**CITY OF PELHAM, ALABAMA
WWTP IMPROVEMENT
INSTALLATION OF GRIT AND GREASE REMOVAL EQUIPMENT**

ADDENDUM NO. 1

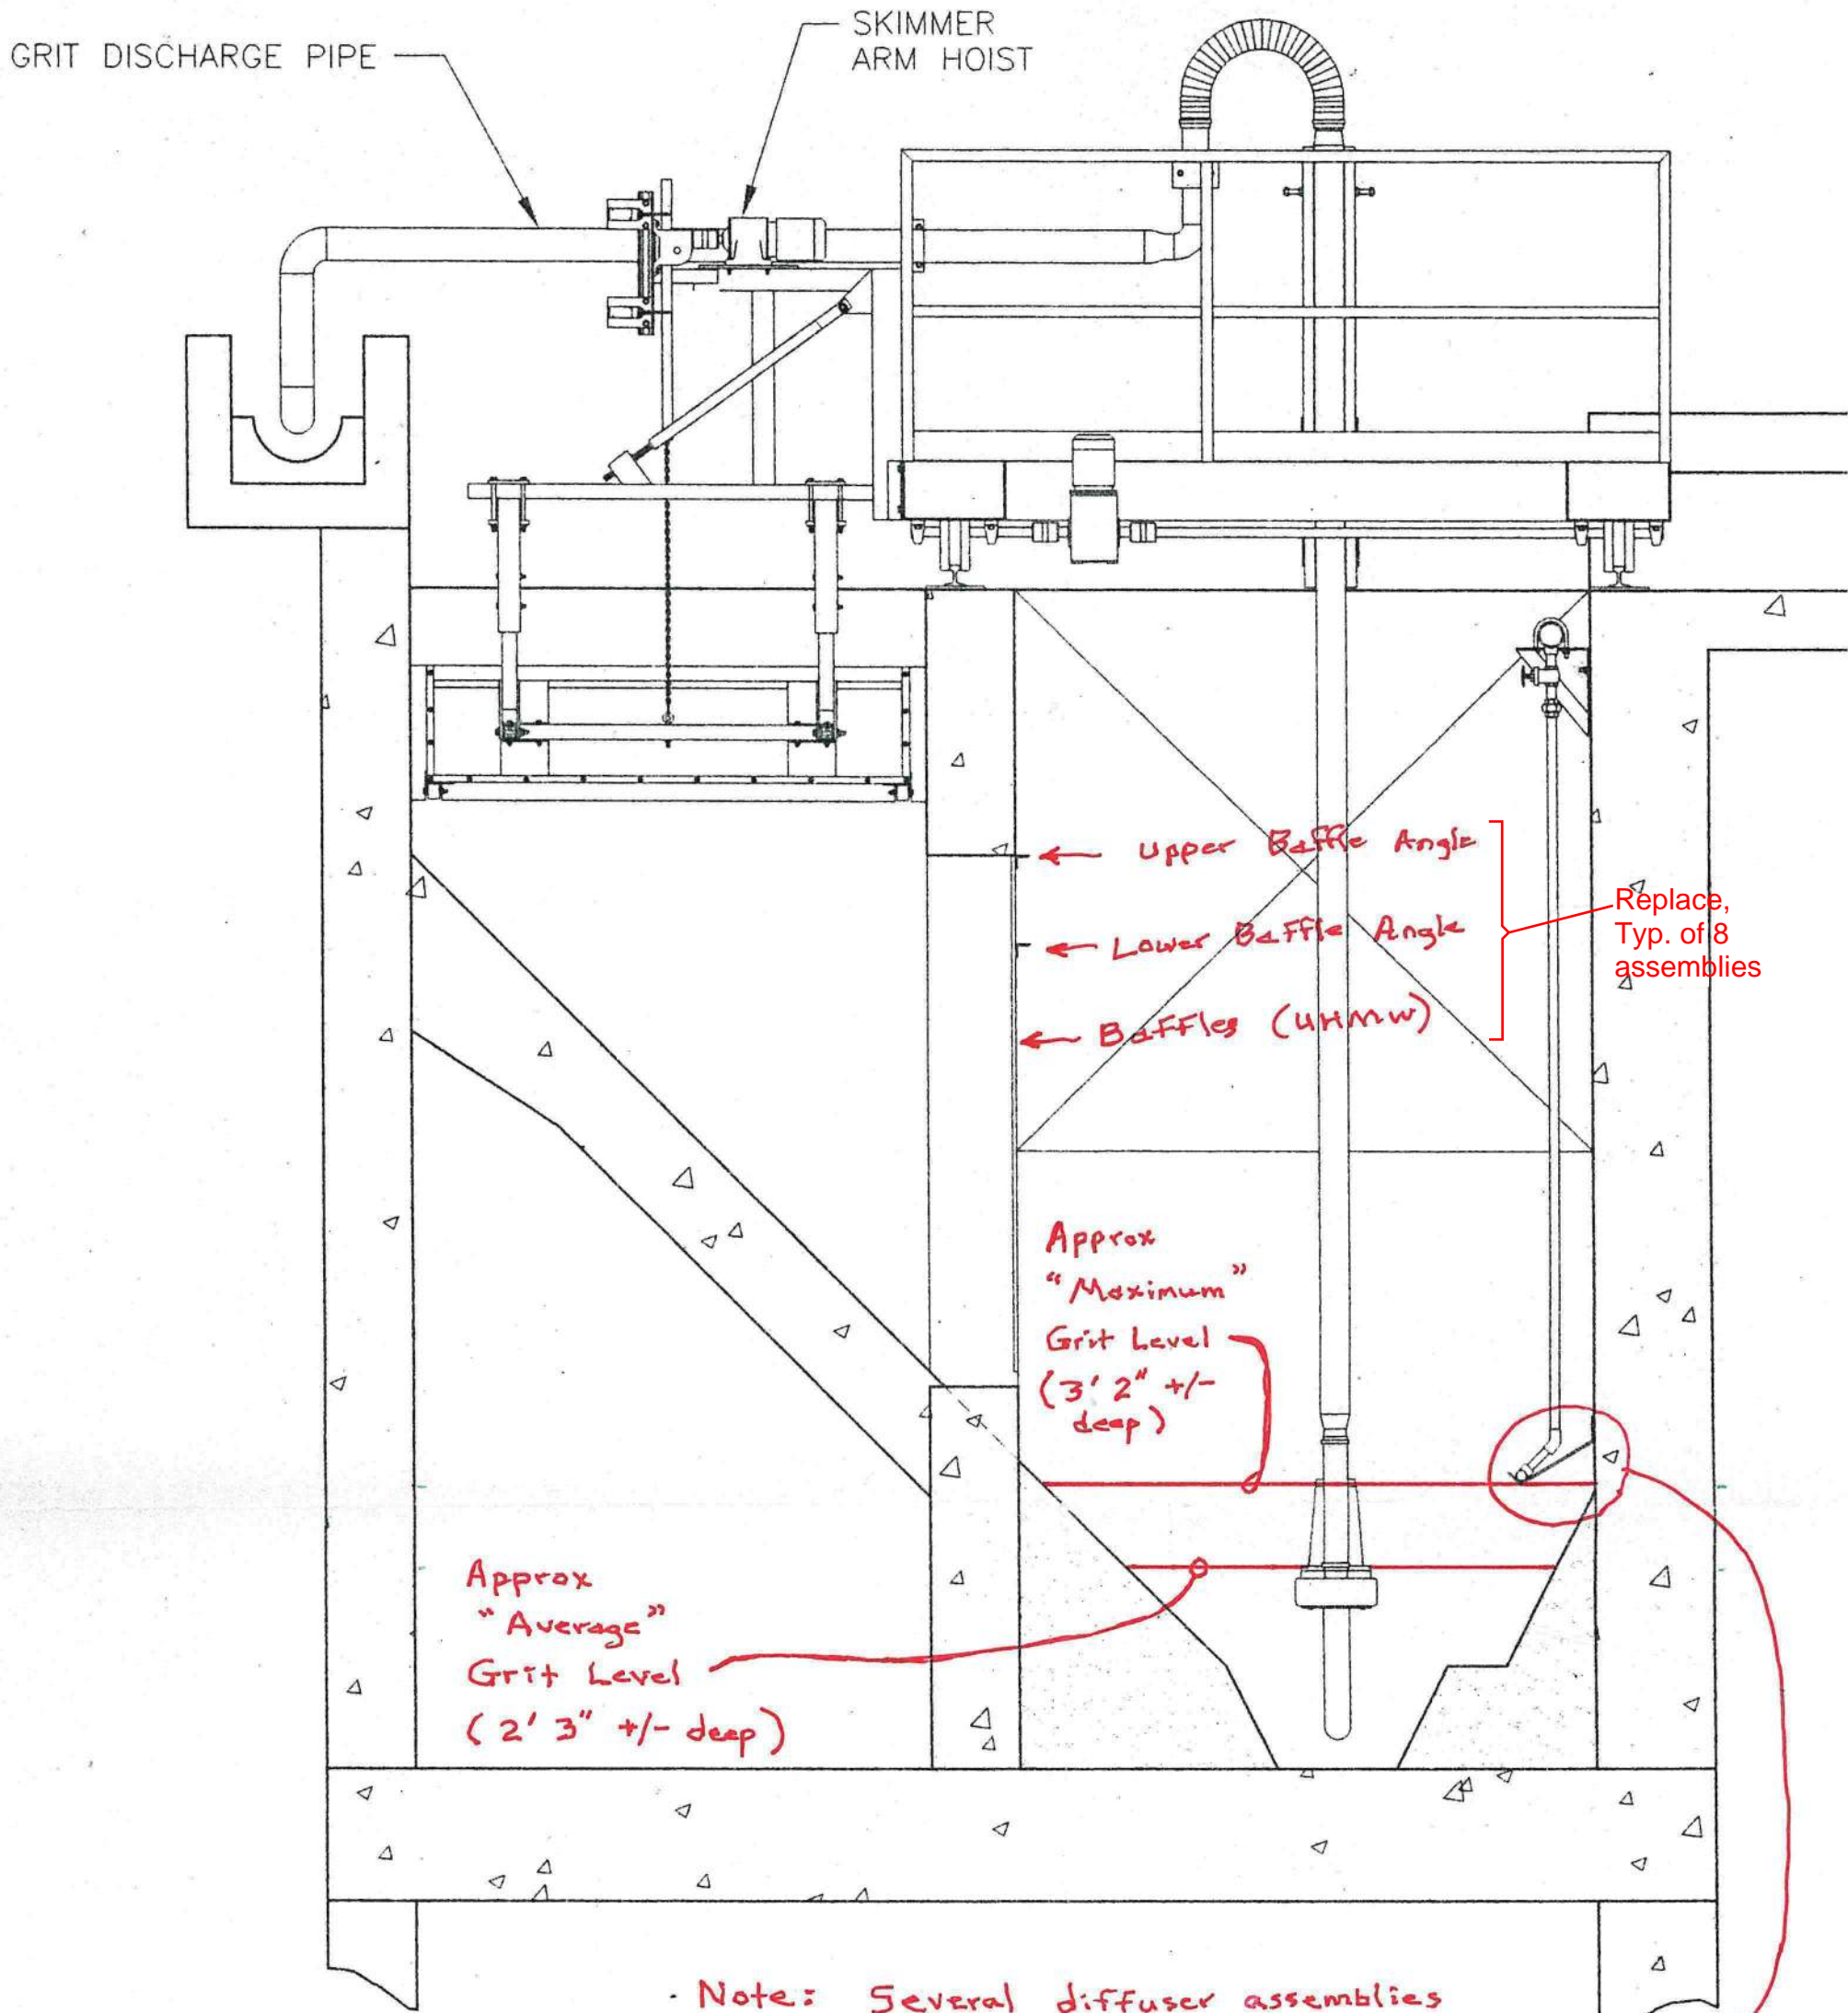
All diffusers have significant rag accumulations. The grit and rags must be removed and hauled to a sanitary landfill at the Contractor's expense. Note that the grit and rags will be wet. The isolation slide gate leaks and therefore some water will continually enter the grit chamber during the work. Note that the drain valve has a broken operator shaft. Furthermore, the invert of the drain valve is above the concrete floor so it will not drain all the water from the tank even if opened. Free water must be drained from the rags and grit before transporting to the landfill. Such water shall be drained into the sanitary sewer.

A photograph of the dewatered grit chamber is attached. It shows some of the grit accumulations in the bottom of the grit chamber as well as some of the gate leakage. It shows some of the rag accumulations on some diffusers on the left side of the photo. Other rag and debris accumulations can be seen on the divider baffles on the right side of the photo.

SECTION C-C
 Use care to prevent damage to diffuser assemblies or support brackets.

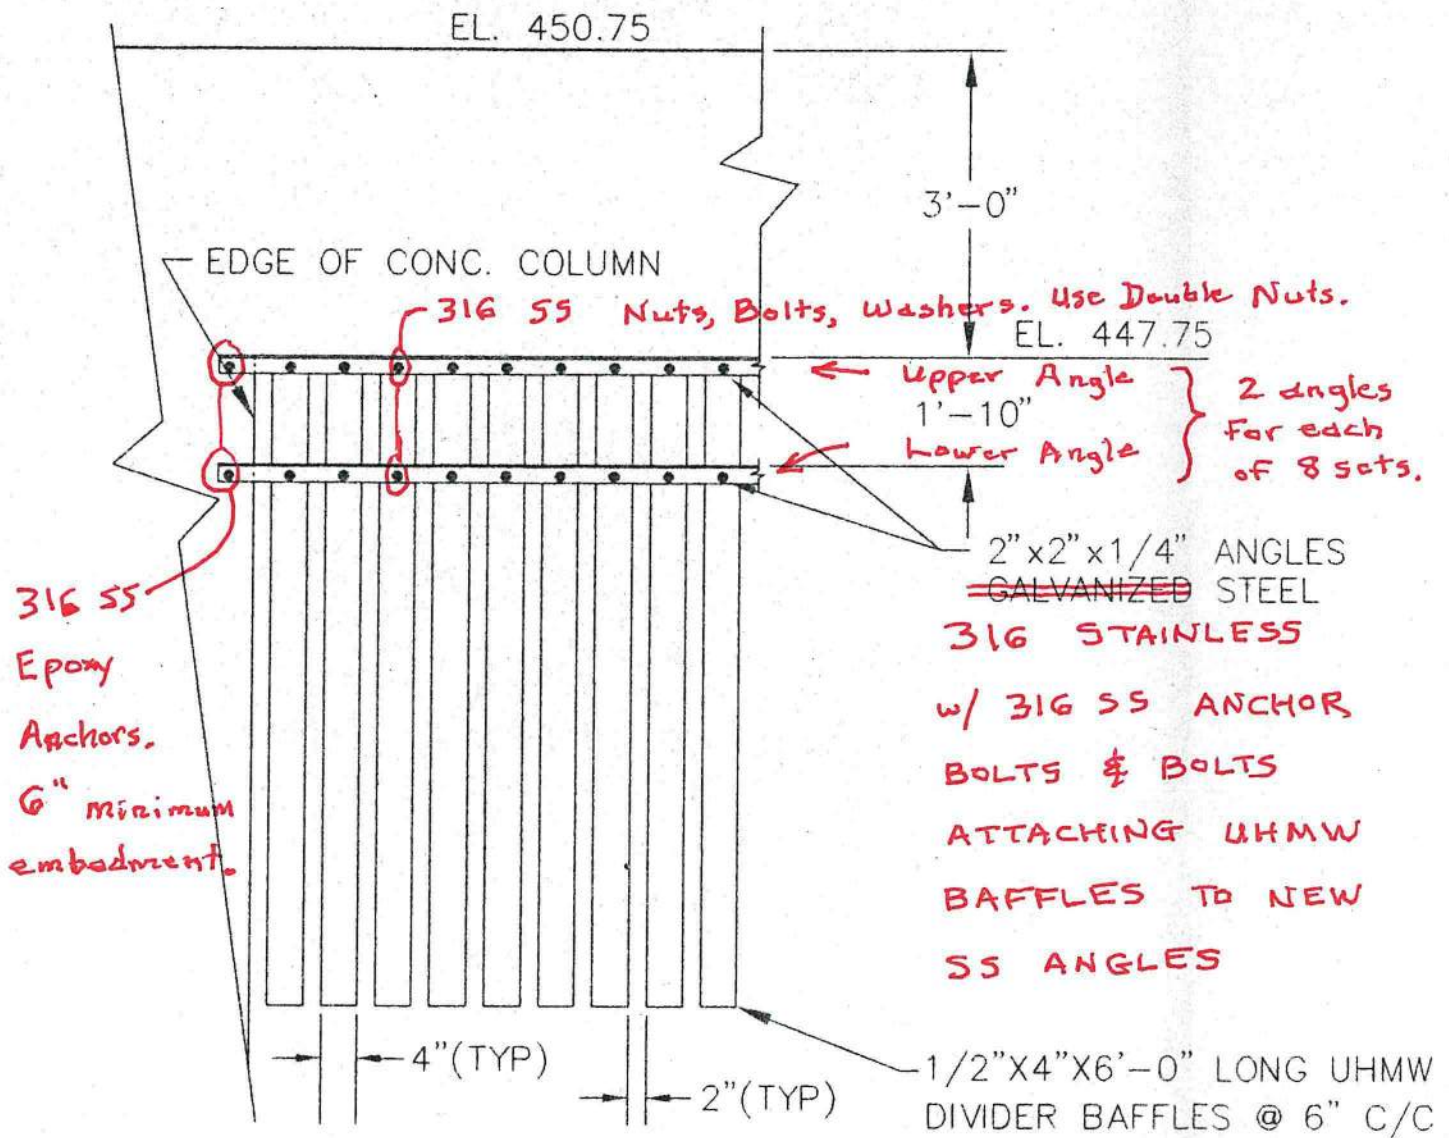
1. Re: Grit and Rag Accumulations: A considerable amount of grit has accumulated in the grit chamber. Some of this may be rags or a mixture of rags and grit. The depth of grit accumulation varies significantly in different sections along the length and across the width of the grit chamber. The approximate "average" depth is roughly 2'3" +/- . The estimated length at the "average" depth is about 60'. The approximate "maximum" depth is roughly 3'2" +/- . The estimated length at the "maximum" depth is about 25'. The maximum depth may exceed the stated amount in several places where the horizontal portion of several diffuser assemblies are completely covered by grit. Use care in the removal of the grit and rags from the diffusers to prevent damage. The estimated approximate depth of the accumulated grit is shown in Section C-C of the addendum.

3. Re: Section C-C: See attached section view for additional information.
4. Re: Divider Baffle Detail: See attached detail for additional information.

· Note: Several diffuser assemblies are completely covered with grit.
 All diffuser assemblies have heavy rag accumulations.
